Department of Energy
 Richland Operations Office
 P.O. Box 550
 Richland, Washington 99352

REQUEST FOR CLARIFICATION OF BWIP SCR (SCR-13)

As requested by your letter dated February 17, 1983, and discussed with you, M. Gordon, M. Webber, NRC; and R. Baca and J. H. LaRue, Rockwell Basalt Project staff on March 9, 1983, the enclosure states the DOE replies to the eight questions which the NRC noted in the subject letter.

908022340

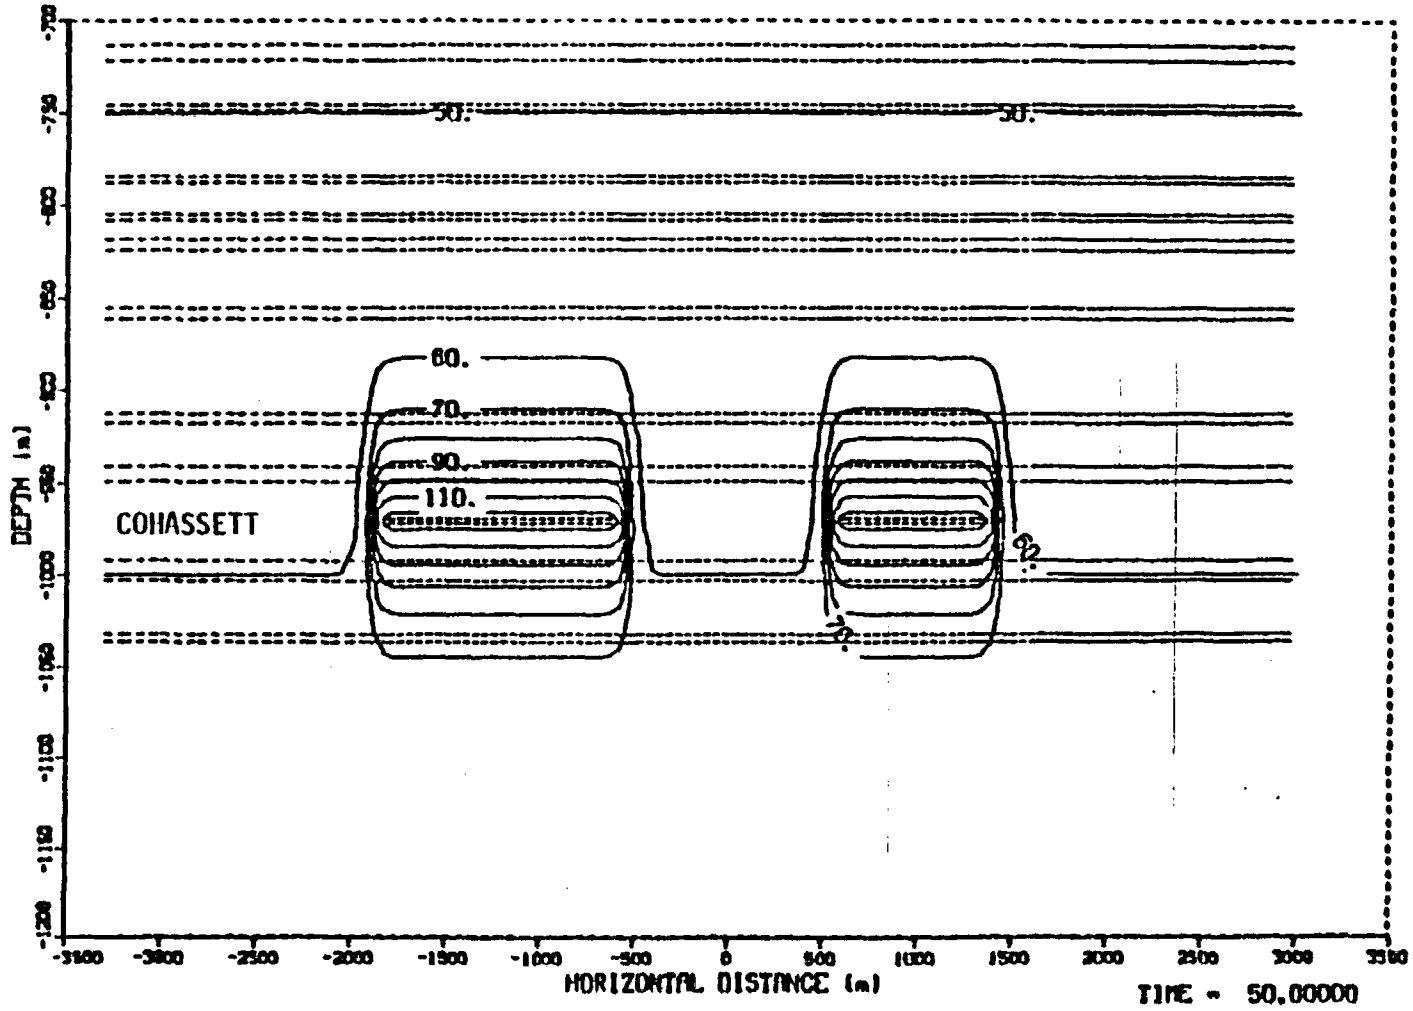
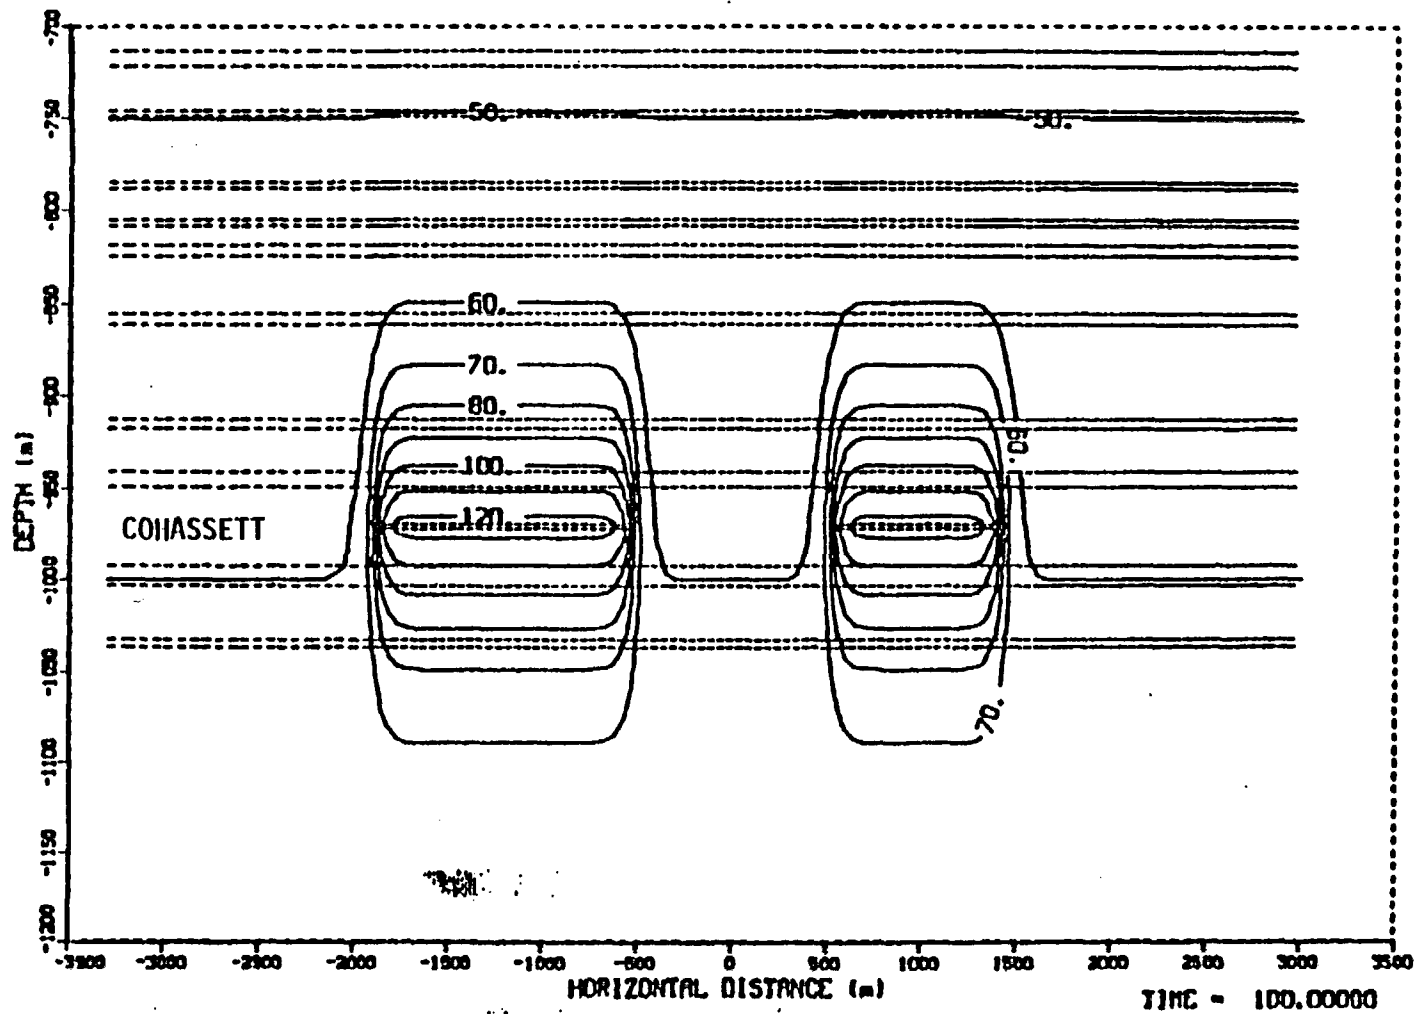
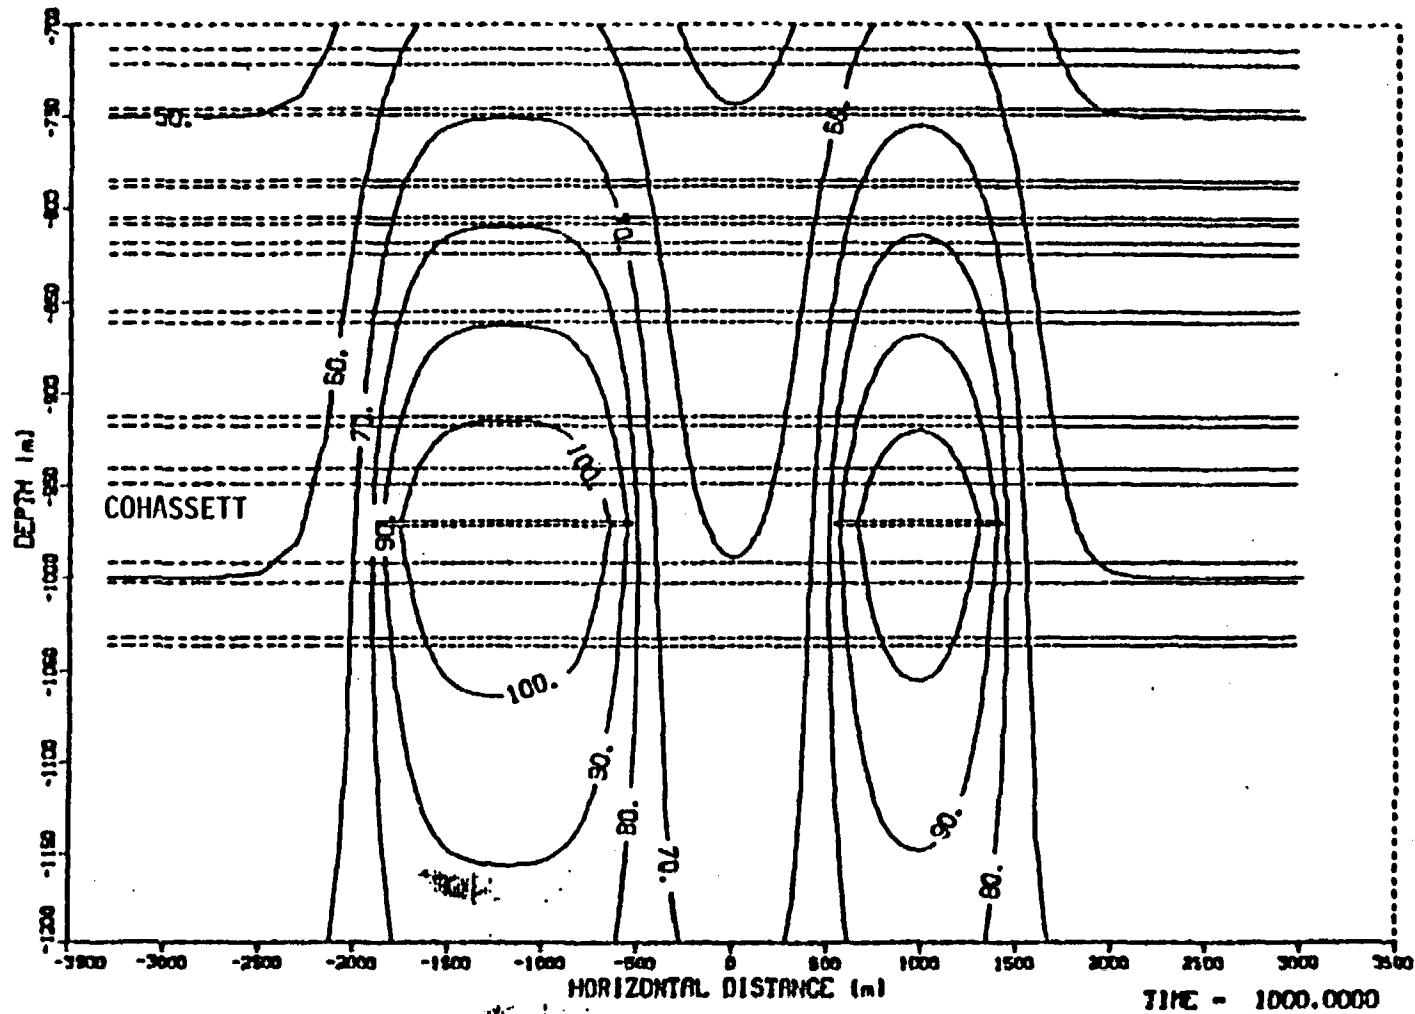
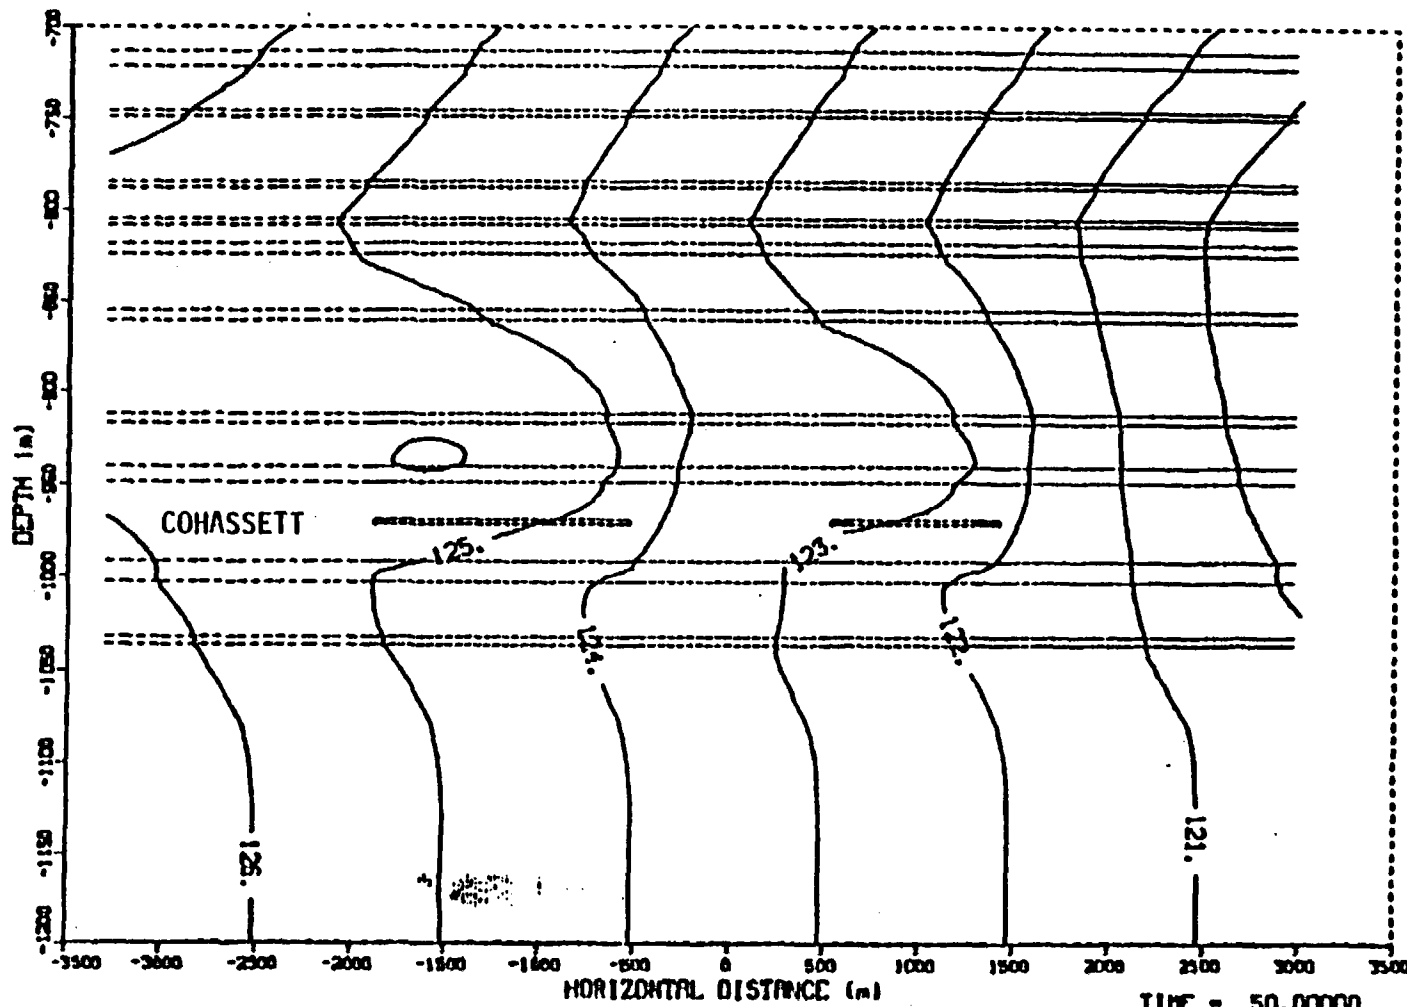
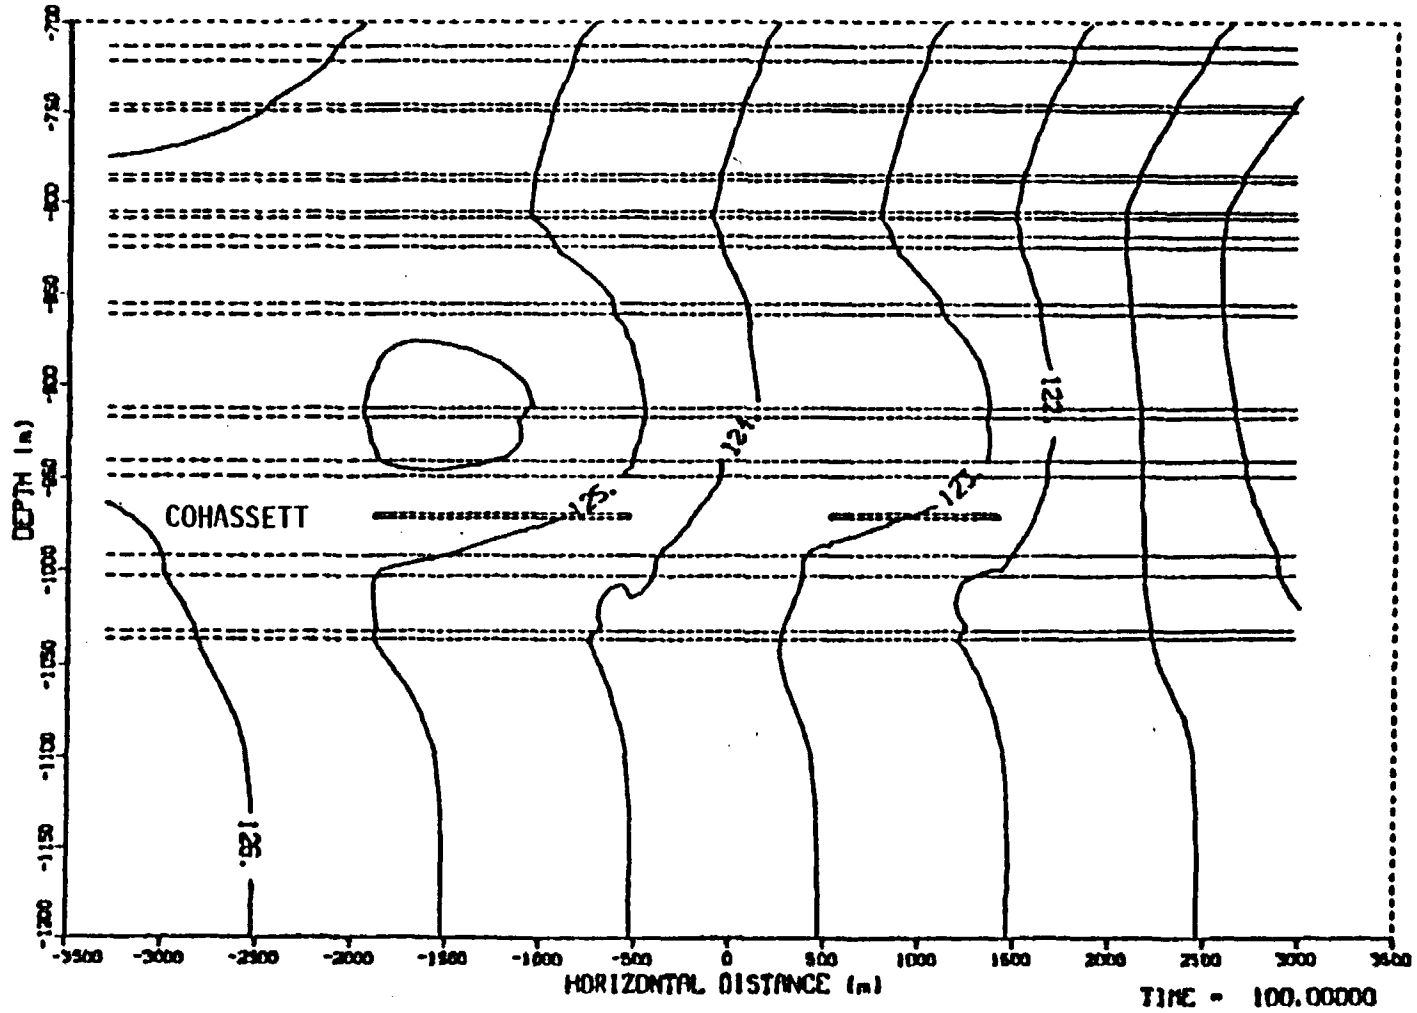
Where does the geothermal gradient (40°C/km) begin in the PORFLO model (eg., at the ground surface, 20 m below, or at the regional water table). What is the temperature, depth and pressure at the repository nodes prior to thermal production by the HLW?

Attached are a series of temperatures (T) and head (h) contour plots which give an indication of the time variations, of T and h around the repository.
